City of Santa Barbara
California

PLANNING COMMISSION
STAFF MEMO

SUBJECT: 3427 Sea Ledge Lane (MST2006-00092, CDP2006-00003)

SITE PLAN

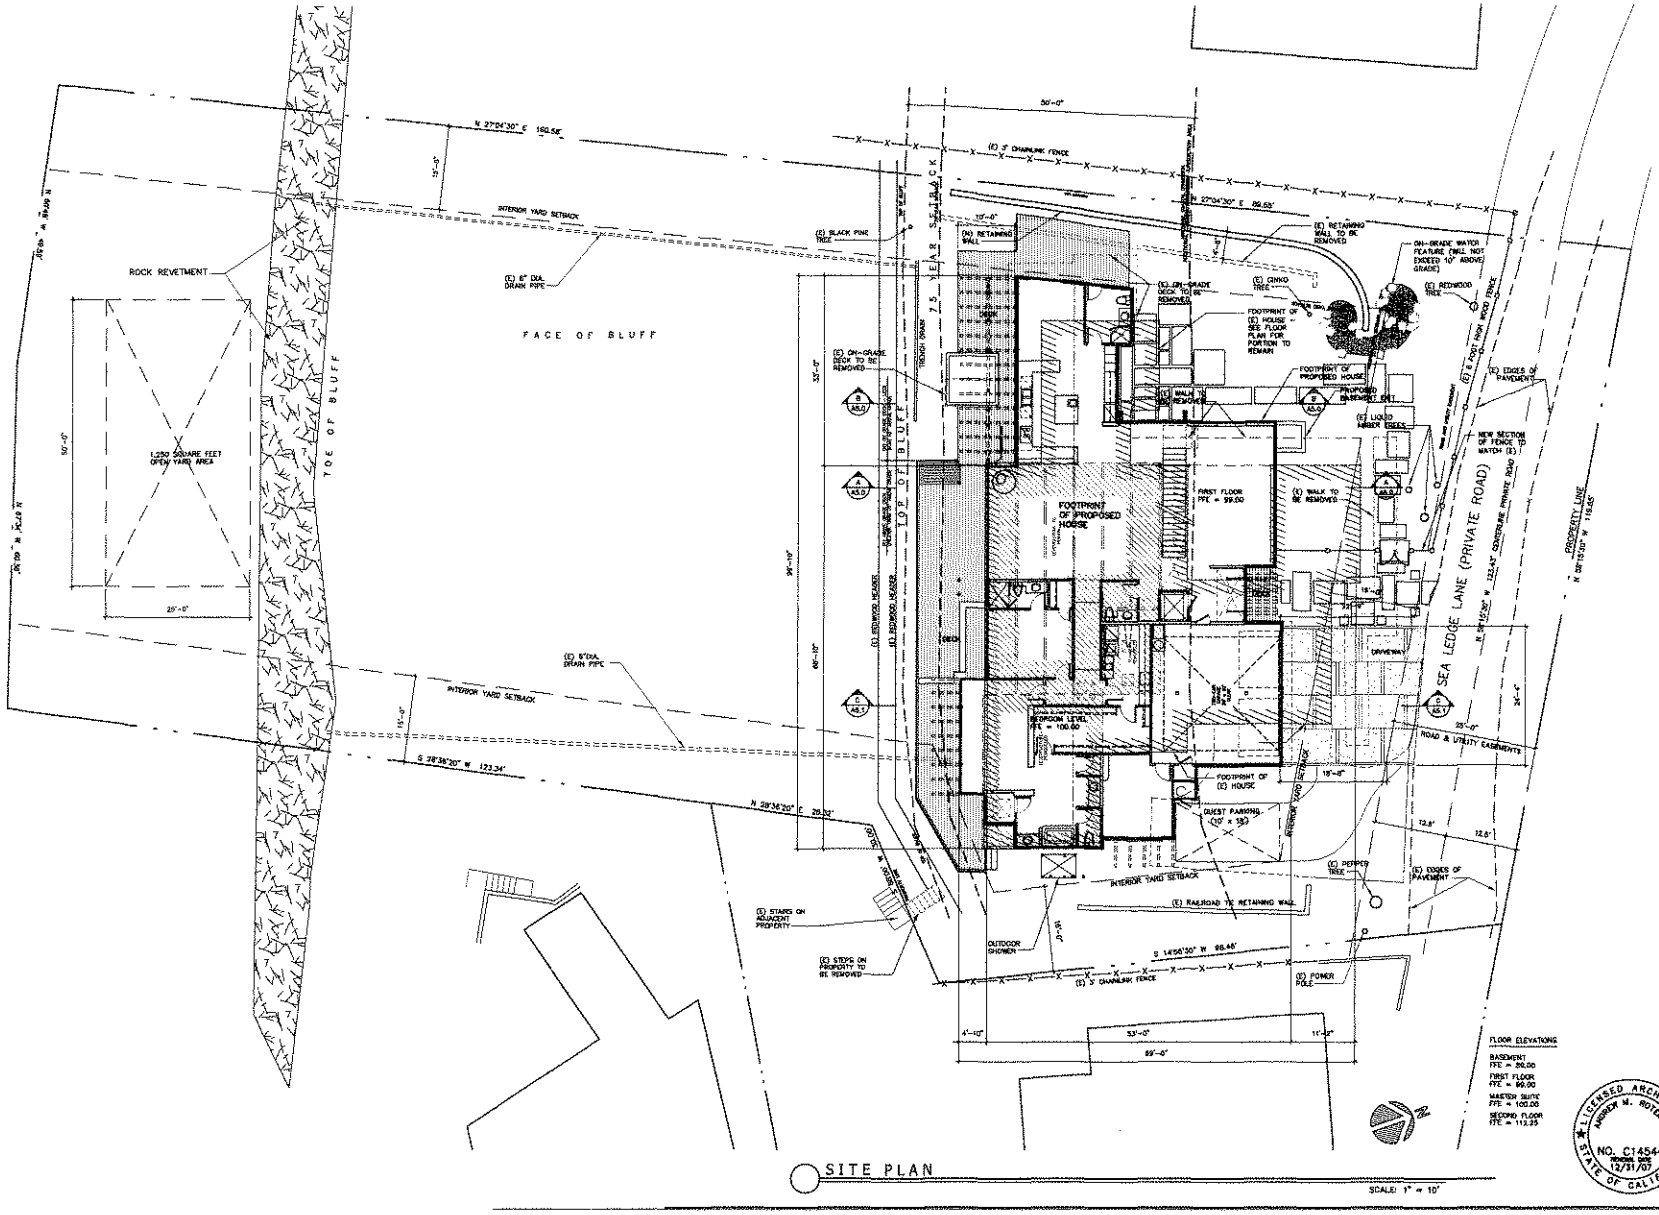
A zoning modification continues to be requested for an as-built section of wood deck encroaching into the interior yard setback at the eastern boundary of the property. Permit records indicate that a portion of this rear deck is not constructed in the previously permitted configuration. The deck is proposed to be repaired in the same footprint. The supporting structure would be left in place and the flooring and guardrail would be replaced.

The applicant is requesting that the proposed condition of approval be revised to allow for repair work within the 75-year geological bluff setback area as well as within the required yard . The size of the deck will not increase and no foundation work is proposed. Proposed improvements include the installation of new decking material and a new guardrail over the cantilevered portion of the deck that encroaches into this setback area. Staff had originally recommended no new work be performed in this area. The applicant believes the present deck location and design aids in the preservation of the bluff top and is requesting that the deck be allowed to remain and repaired as presently situated. No disturbance of the bluff top would occur as part of the repair. The geotechnical report that analyzed the project states that continuing to prevent rain water from reaching the bluff top would reduce future erosion. Allowing the deck to remain in the interior yard setback is not necessary to secure an appropriate improvement, prevent unreasonable hardship or promote uniformity of the improvement. Staff believes that portion of the deck should be removed. However, the applicant has presented valid arguments for retaining the deck that cantilevers in the 75-year bluff setback. The Planning Commission should consider these arguments in making this decision. If the Commission chooses to leave the deck in place, proposed condition B.5 should be revised accordingly.

5. **Meet Zoning and Coastal Setback Requirements.** Redesign and relocate the bluff-side deck and all building elements to be outside the required zoning setback. Additionally, the deck shall be relocated outside the 75-year bluff setback.
